ADDENDUM

ADDENDUM NO.: 05
PROJECT NAME: 1819 W. Pershing Renovation (Pershing Road Center Building)
PBC PROJECT NO.: 04026
BID PACKAGE NO.: Bid Package #1
DATE OF ISSUE: 12.30.22

PBC Project Name: 1819 W. Pershing Renovation
PBC Contract No:
Project No: #04026
Title:
BASEMENT ELECTRICAL POWER PLAN - NORTH WEST BLDG

Sheet
E-200

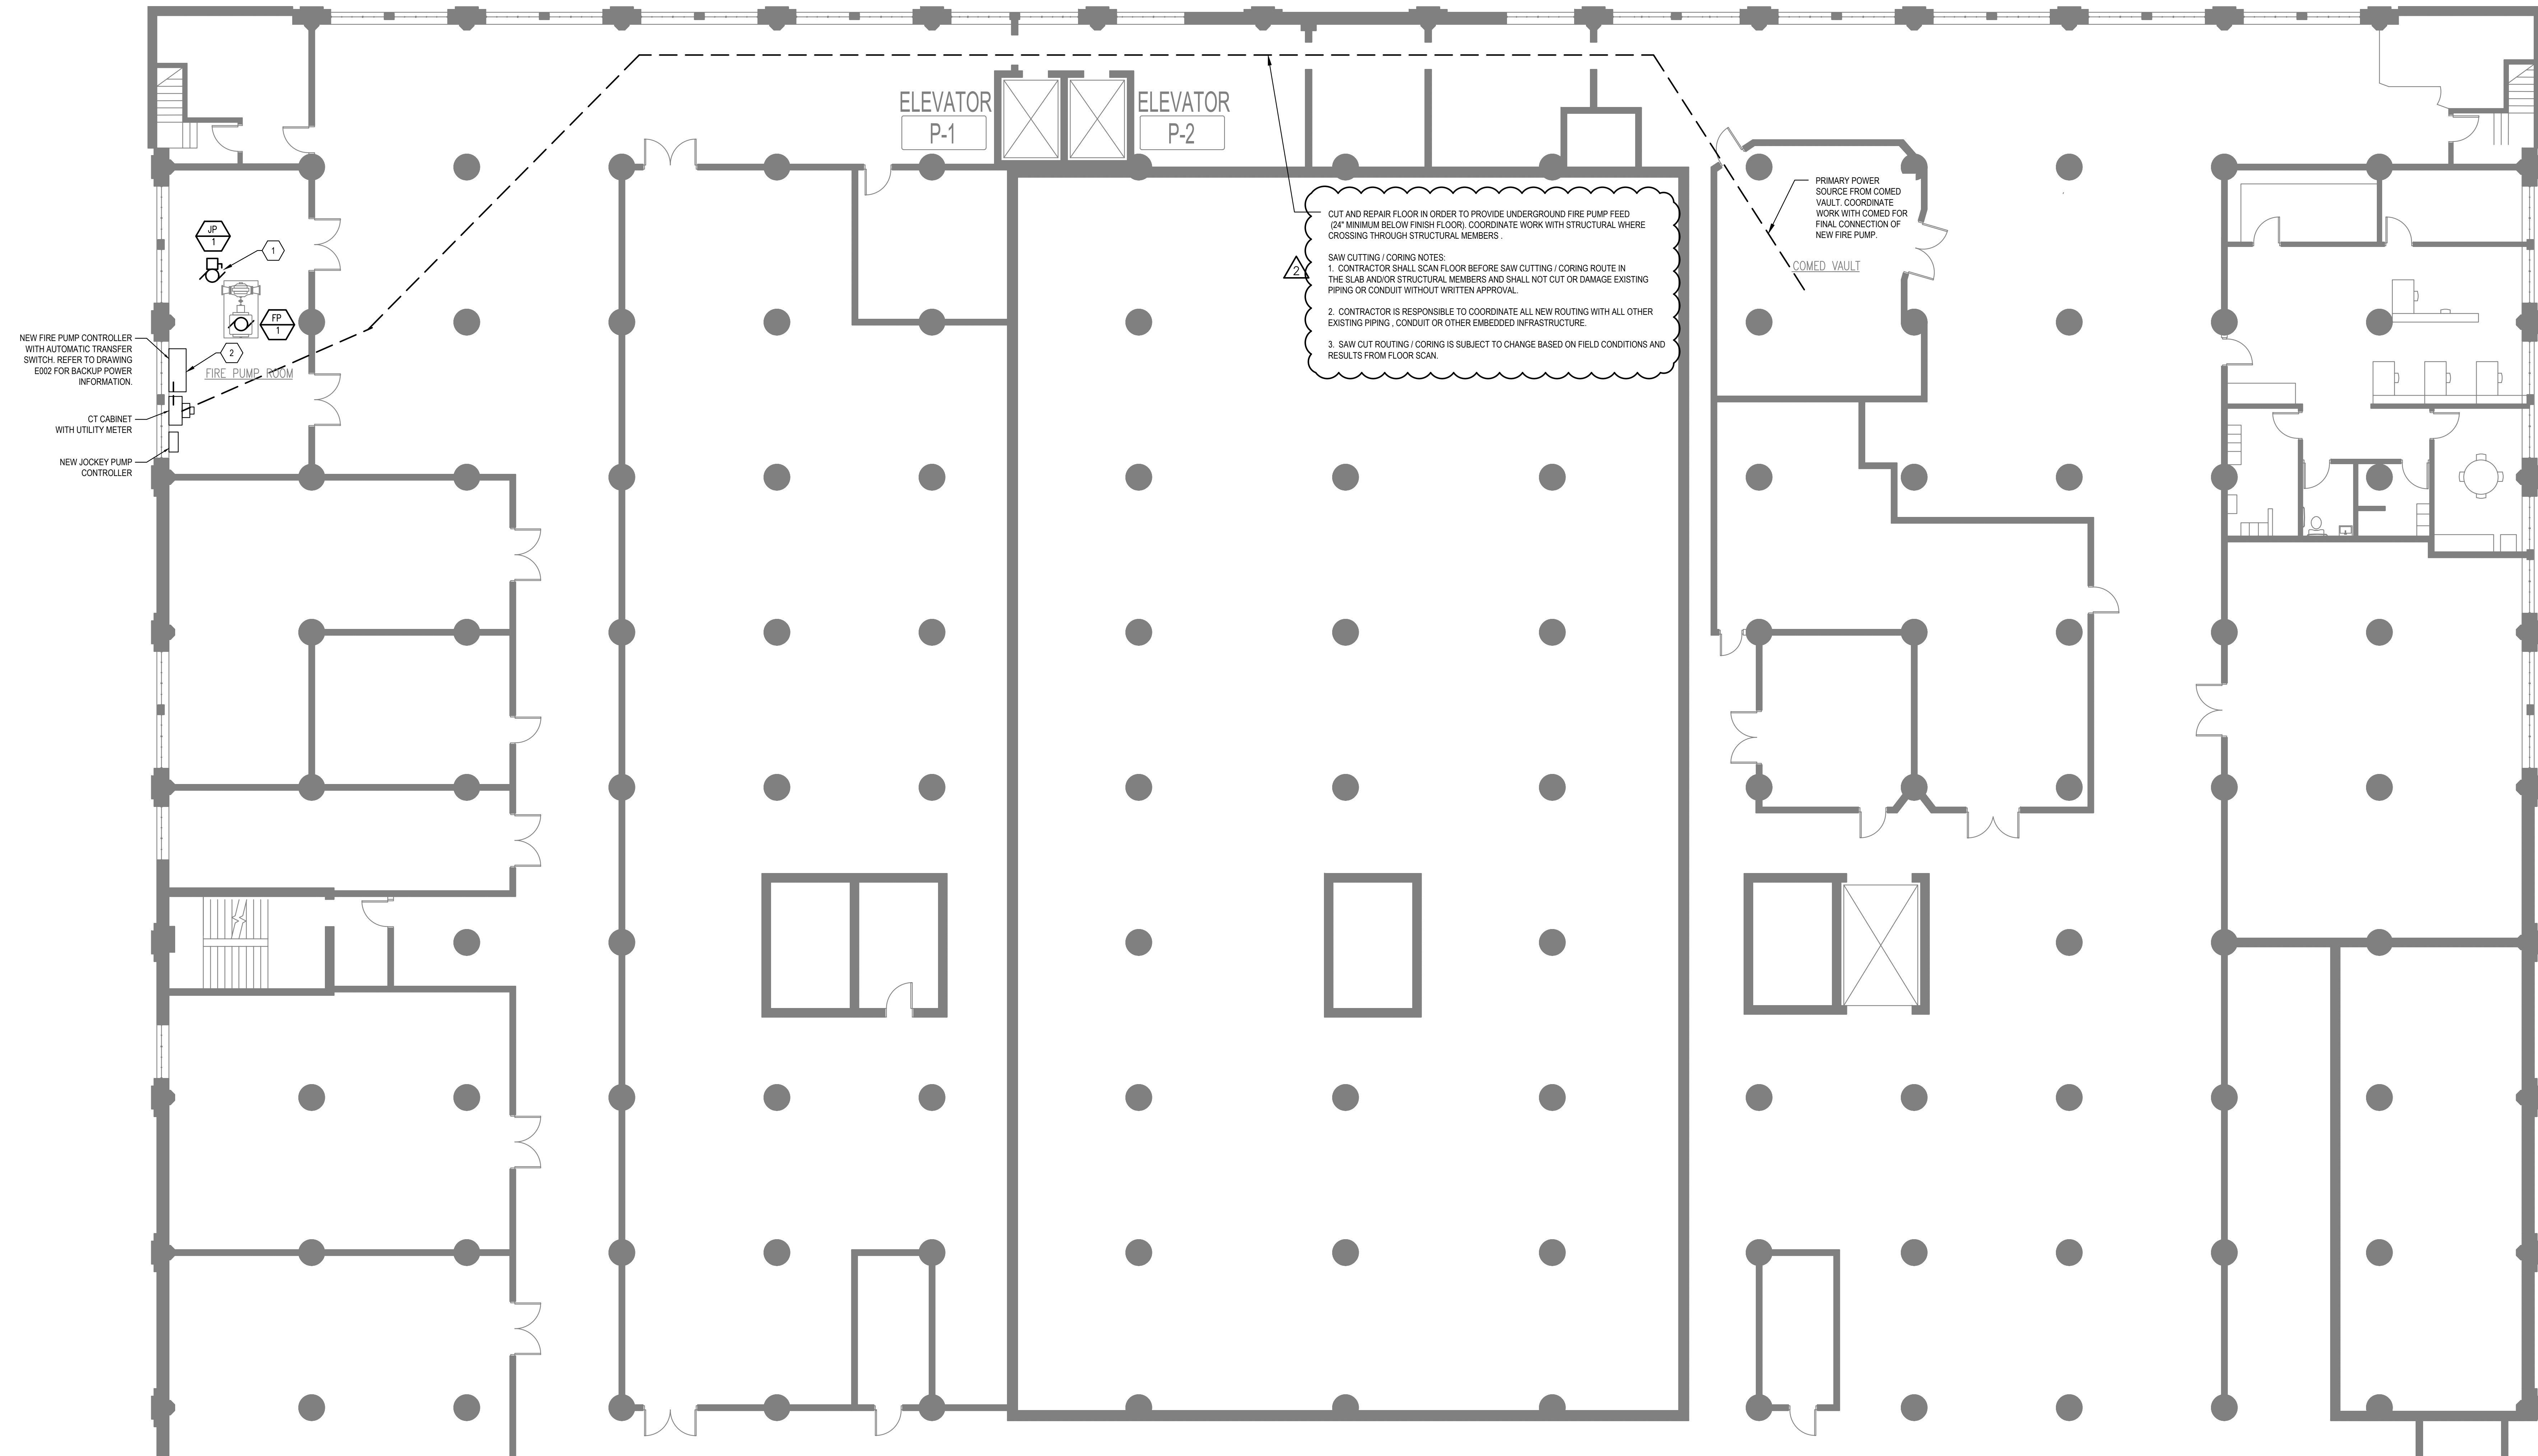
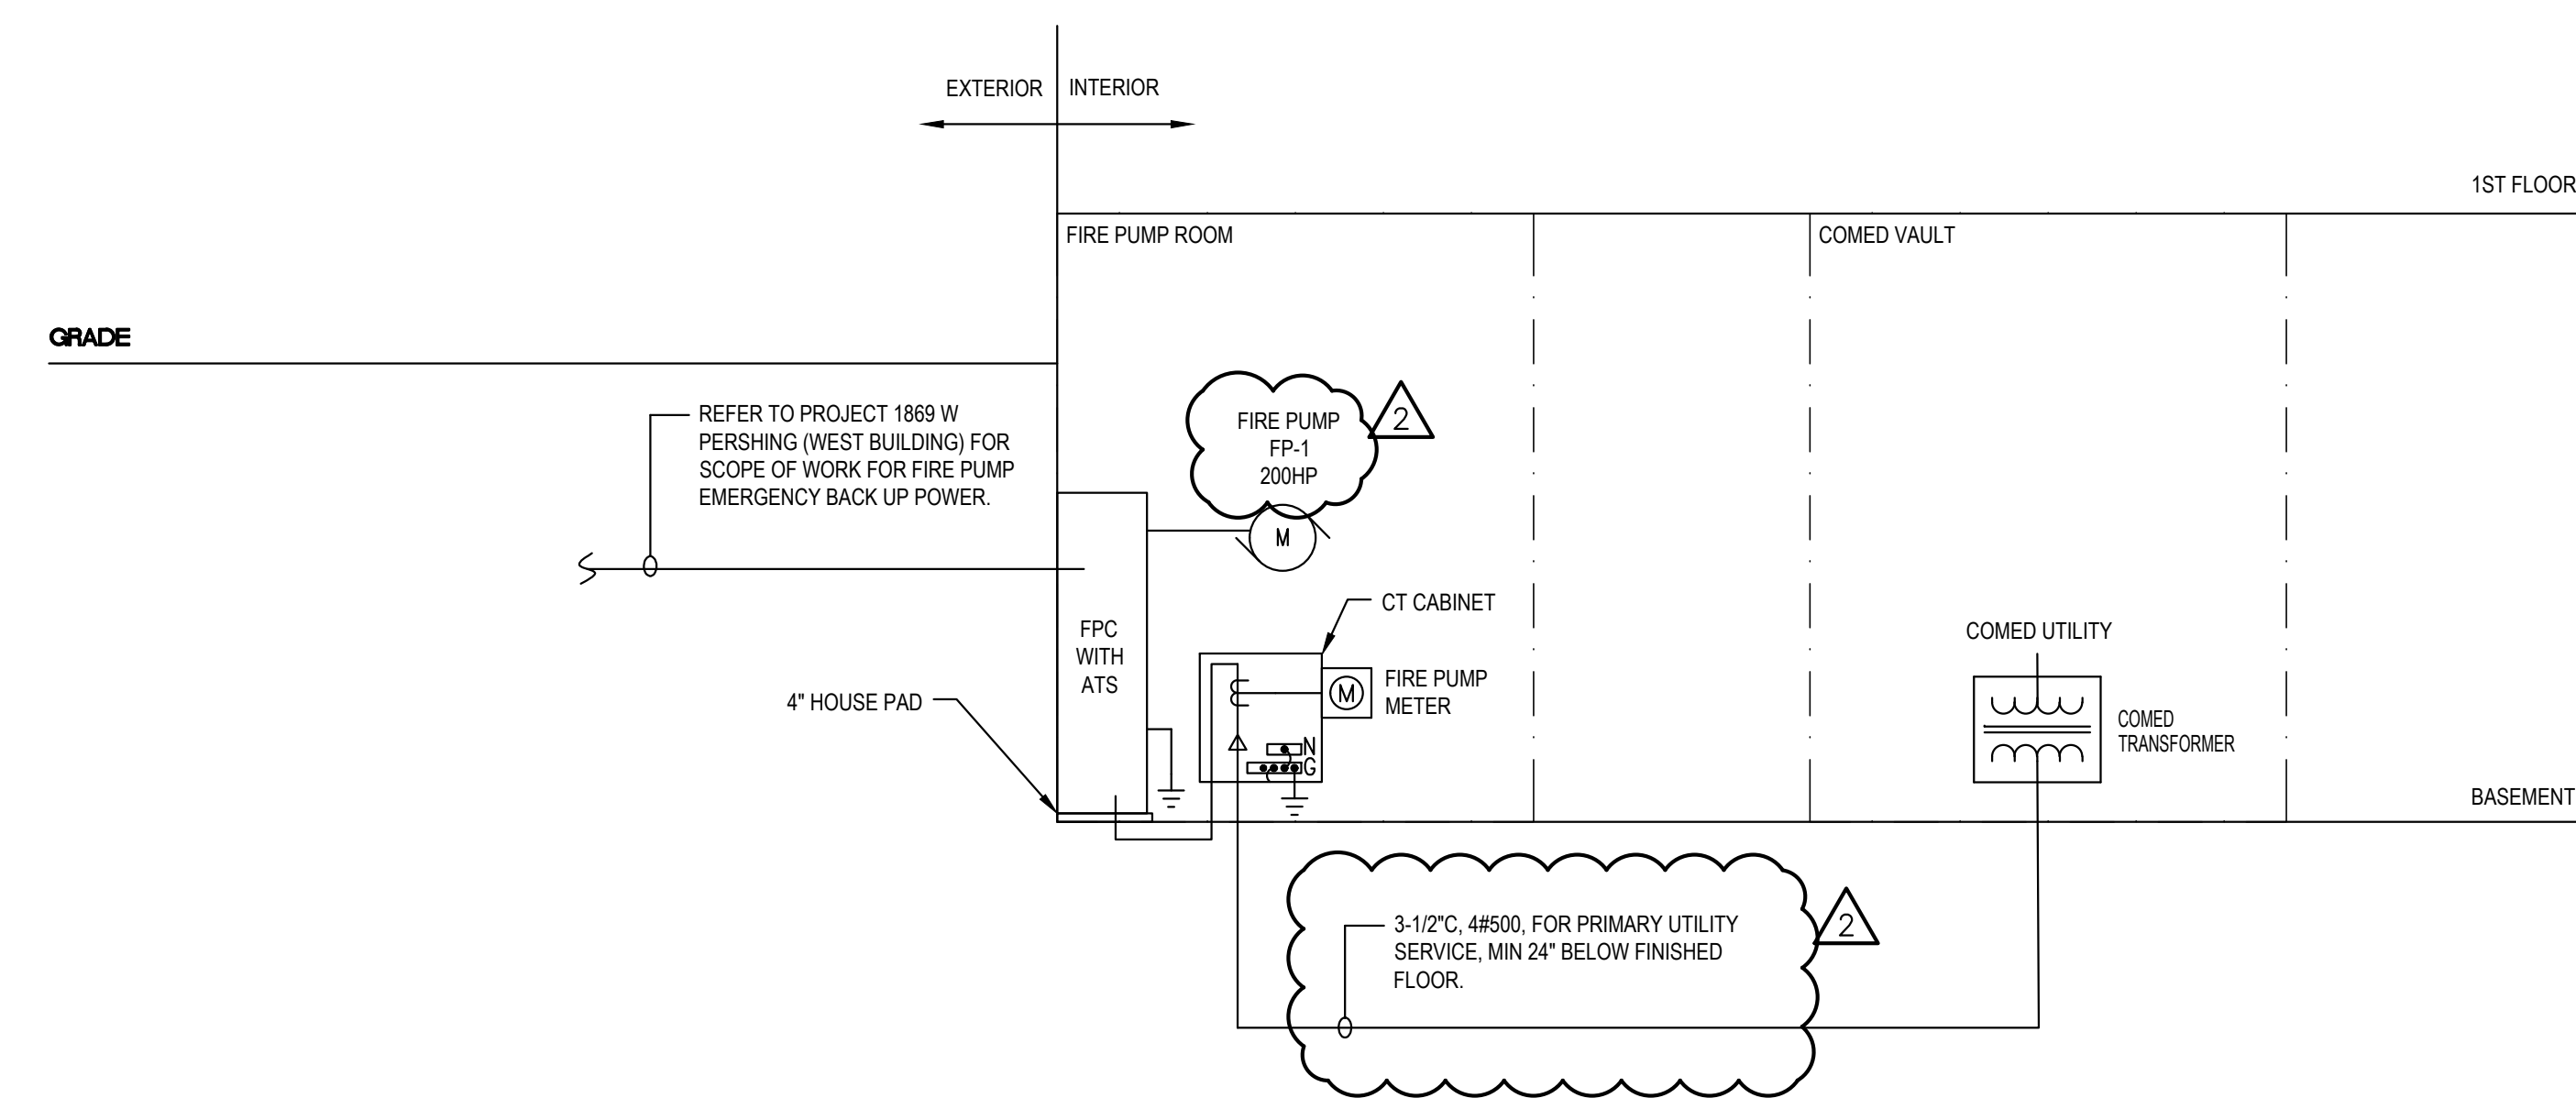
CHANGE 1 NEW E-200 BASEMENT ELECTRICAL POWER PLAN – NORTH WEST BLDG.

2. **(Question) Is the installation of a new power feed to the new fire pump part of project #04026 Bid Package #1? If so, we would need to know the pipe & wire size required and where the normal and emergency power originate from.**

- **Response:** Yes, a new power feed for the fire pump is part of the project. Bidders are advised to refer to E-200 Basement Electrical Power Plan – North- West BLDG. included in this Addendum 5 for full details related to pipe size, wire size and pipe location.
